Objection (4) to AW-155-17-PL – Build house in front garden of Brus Lodge, 28 Kingsway – 12-7-2017

OBJECTION (4) TO AW/155/17/PL - Build Detached House in front garden of Brus Lodge, 28 Kingsway, within the Craigweil House Conservation Area and the Craigweil House Area of Special Character.

ARBORICULTURAL REVIEW OF PLANNING APPLICATION AW/155/17/PL

Brus Lodge - 28 Kingsway, Aldwick

south elevation

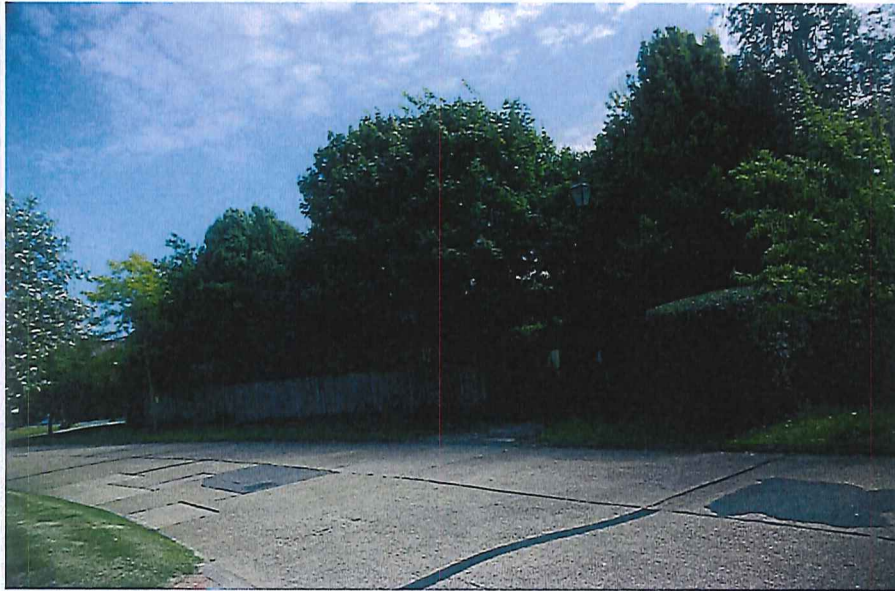
‘Little Fellows’, 31 The Drive, the very first house designed by Joshua Auty, FRIBA, instructed by Sir Arthur Du Cros (and built and gifted by him to his daughter as a wedding present!) enjoys, as part of its setting, the spacious north view as seen in the attached photograph. However, if this house is allowed then the view will be bricks and mortar and none of the trees and greenery to the north will be seen. A line from the pitch of the roof of Brus Lodge, on the right, shows the approximate height and that splendid view will be destroyed. Further, the house extends south, towards Little Fellows, to the point where the swimming pool is cut off from the photograph. Bricks, mortar and many over-looking windows, as in the ‘South Elevation’, will replace the 84 year old outlook!

That can only be harmful to the setting of the heritage asset and the CA but also conflict with the provisions of Planning Policy GEN7 in that ((iv) *it will have an unacceptable adverse impact on adjoining property etc; (ii) it fails to respond positively to the identified characteristics to create attractive places and spaces and respects and enhances local distinctiveness* ‘and that the scheme fails to display high quality design and layout appropriate to its immediate setting. Manifestly it fails these tests of GEN7.

- 3.8 Viewed from the north-west side of the application site from Kingsway - the individual specimen Norway Maple and Pittosporum are highlighted.

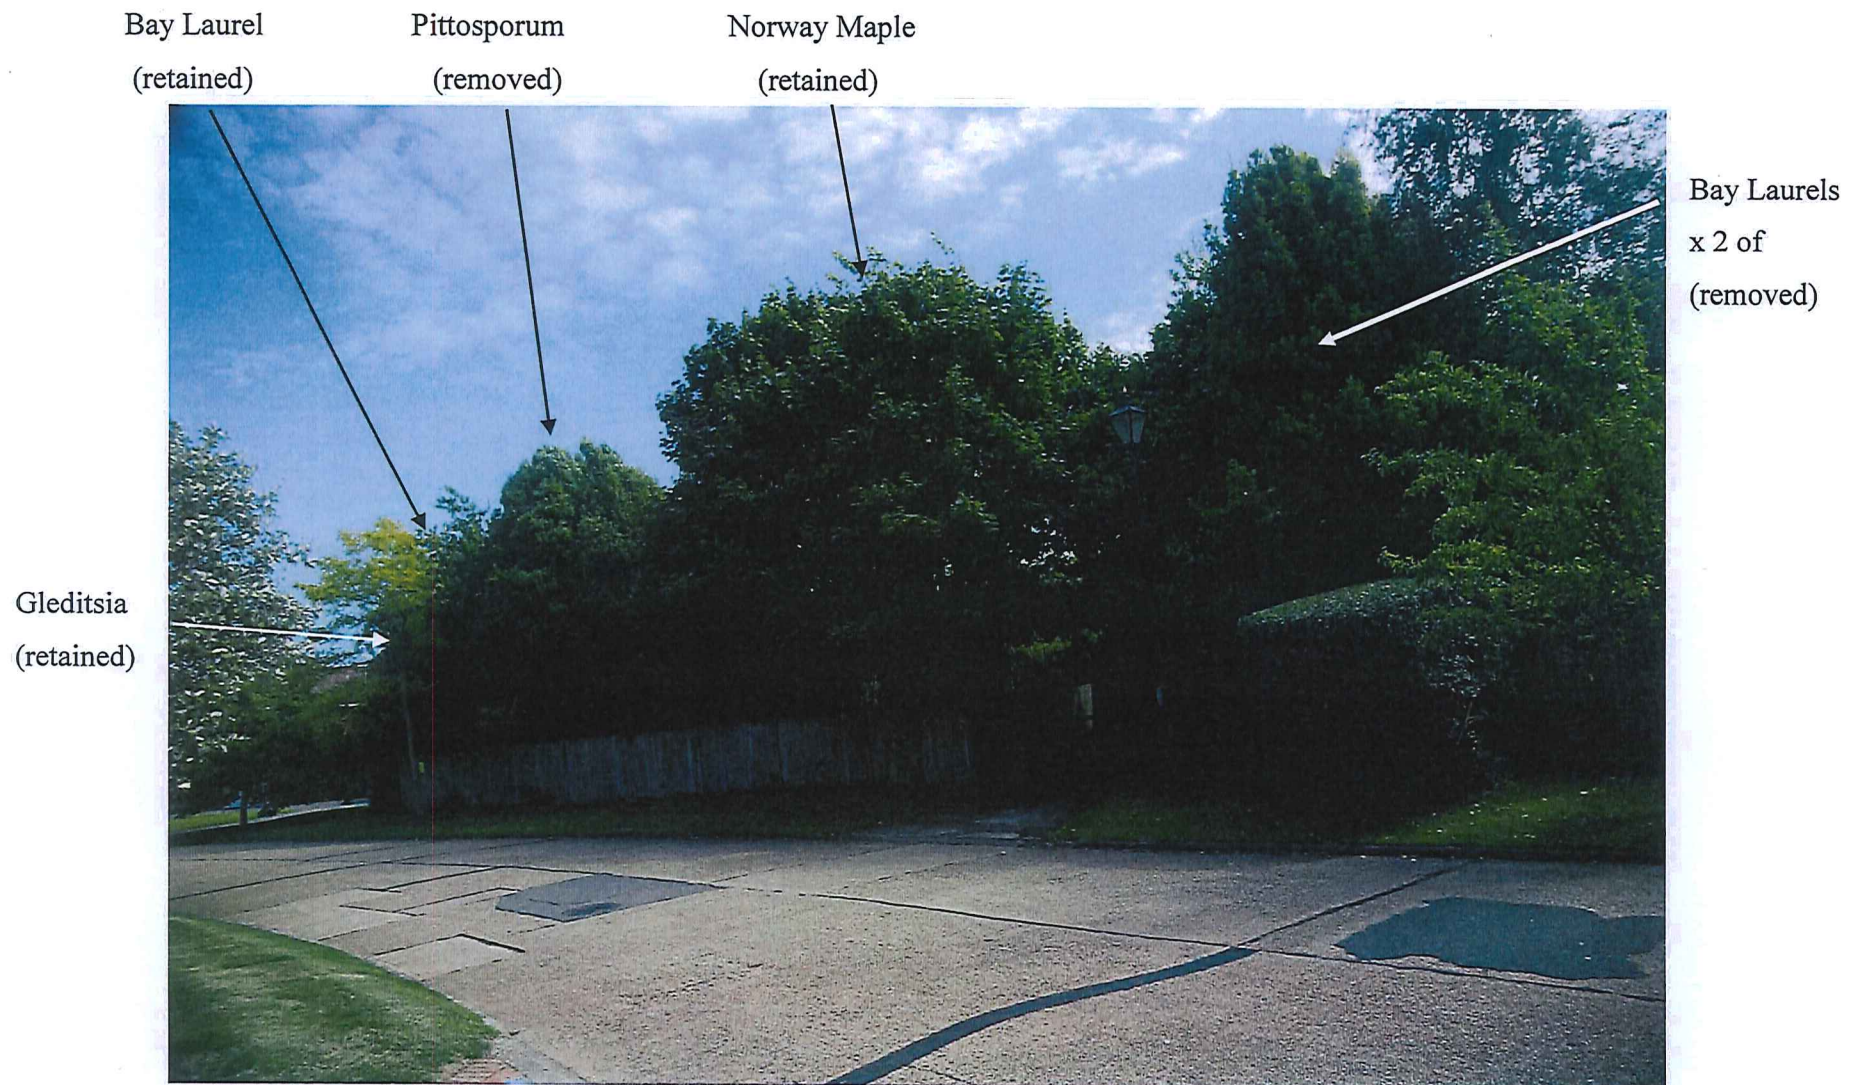
- 3.6 Viewed from the south side of the application site from within the rear garden of 31 The Drive the importance and significance of the evergreen screen of trees is abundantly clear as no properties along the northern side of Kingsway can be seen. The individual specimen Norway Maple and Pittosporum are highlighted.

- 3.7 Considering again and viewing the site again as described in items 3.4 to 3.6 above, the view which I held and reported on in January 2016 is only reinforced and I remain firmly of the view that the site frontage trees at this location [from the eastern boundary with Brus Lodge to the boundary with No 24 Kingsway] relate as an entity in the landscape and thus should have been preserved as such in Group format under the Tree Preservation Order and not as individual trees.

- The best of the individual evergreen trees is a Pittosporum which has been recognised for its value in the landscape by being TPO'd.
- I have highlighted this tree in the photographs at Section 3 of this report but note that in their survey it has not been afforded a tree number and has been lumped in with a Shrub grouping thus again undermining its value and significance in the landscape.
